Agenda
HAILEY PLANNING & ZONING COMMISSION
Monday, June 1, 2020
Virtual Meeting
5:30 p.m.

FINDINGS OF FACT, CONCLUSIONS OF LAW AND DECISION

On May 18, 2020, the Hailey Planning and Zoning Commission considered a Design Review Application by Tanner Investments, LLC on behalf of Brant Tanner, represented by Galena Engineering, for amended Woodside Subdivision No. 25. The subdivision will consist of six (6) four-plex apartment buildings, for a total of twenty-four (24) apartment units comprised of twenty-four (24) 2-story townhomes, each unit ranging in size from approximately 1,040 square feet to 1,324 square feet. A total of 68 uncovered spaces are also proposed. This project will be located at Block 86, E side of Woodside Blvd. btw Antelope Dr. and Baldy View Dr within General Residential (GR) Zoning District.

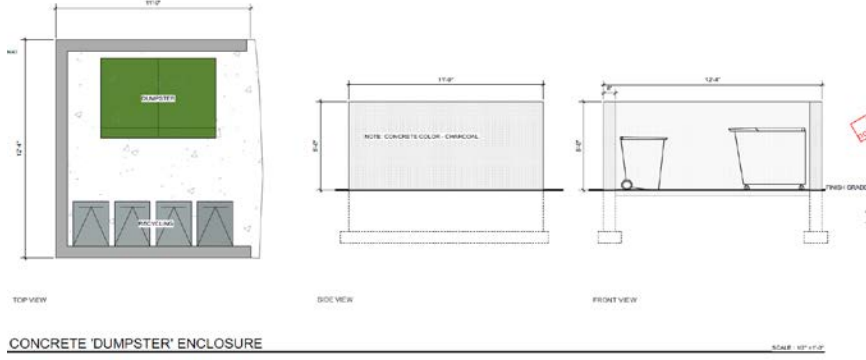
Staff Comments

A Landscape Plan has been submitted (L – 1.0) that shows 75 new trees to be planted, which was increased from an original proposal for 50 new trees. No existing trees exist on site. See plan below.

<p><i>The Applicant is also proposing that 19 trees be a minimum of three-inch (3") caliper, which meets the minimum requirement that twenty percent (20%), or a total of 15 trees, be at least three-inch (3") caliper.</i></p> <p><i>Furthermore, the Applicant is proposing that 22 trees be a minimum of two-and-one-half-inch (2 ½") caliper, which meets the minimum requirement for 20%, which is 15 total trees of at least two-and-one-half-inch (2 ½") caliper.</i></p> <p><i>City Staff provided the caliper requirements to the Applicant and discussed the need to update the Landscape Plan to meet the requirements. The Landscape Plan was resubmitted and complies with the tree caliper requirement.</i></p> <p><i>The Commission and Applicant discussed moving three large trees along the pavement between buildings 2A and 3A to the perimeter along the back of the property to provide more space for snow storage and to provide more screening along the perimeter. This has been made a Condition of Approval.</i></p> <p><i>The Commission suggested alternating deciduous and evergreen trees along Woodside Blvd. to provide more year-round screening instead of seasonal. The Applicant was unsure if alternating tree types was advisable but is agreeable to consider solutions that provide more consistent screening throughout the year. This has been made a Condition of Approval.</i></p> <p><i>The Commission found that this standard has been met.</i></p>

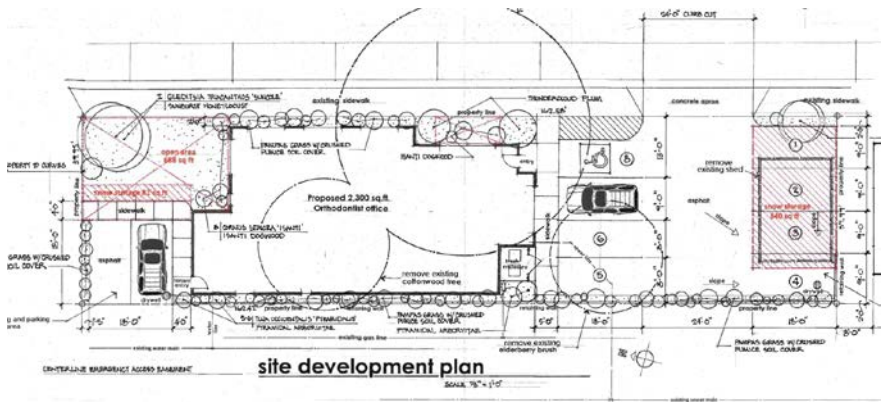
Staff Comments	<i>There are a variety of trees, plants and shrubs proposed for this project. Limited width of many of the planting areas will of necessity require smaller plantings with limited spread. The trees planned for this application are within the growth limits of their respective planting areas. Staff has concerns that:</i> <ul style="list-style-type: none"> <i>The 2 Gleditsia trees planted at the corner of the building appear to be planted right next to one another. They may be too close together. Is there a way to delineate 1/8" to know how far 1' is on the plan?</i> <i>The thundercloud plum trees will produce fruit that is edible and will attract wildlife and will also drop onto the sidewalk, which is messy and not maintenance friendly.</i>

<p><i>Staff requested that the Applicant make these changes to the landscape plan. The Applicant has agreed to adjust the spacing of the Gleditsia trees and replace the thundercloud plum trees with Honey Locust trees.</i></p> <p><i>The Commission found that this standard has been met.</i></p>
<input type="checkbox"/>	<input type="checkbox"/>	<input checked="" type="checkbox"/>	17.06.080(A) 4e	<p>e. Seasonal plantings in planter boxes, pots, and/or hanging baskets shall be provided to add color and interest to the outside of buildings in the LI and SCI-I zoning districts.</p> <p><i>Staff Comments</i> <i>N/A - There are no planting boxes or hanging baskets planned for use in the landscaping.</i></p>
<input checked="" type="checkbox"/>	<input type="checkbox"/>	<input type="checkbox"/>	17.06.080(A) 4f	<p>f. Plantings for pedestrian areas within the B, LB, TN and SCI-O zoning districts shall be designed with attention to the details of color, texture and form. A variety of trees, shrubs, perennials, ground covers and seasonal plantings, with different shapes and distinctive foliage, bark and flowers shall be used in beds, planter boxes, pots, and/or hanging baskets.</p> <p><i>Staff Comments</i> <i>There are a variety of trees, plants and shrubs proposed for this project. There is no plant list.</i></p>  <p><i>The Commission found that this standard has been met.</i></p>
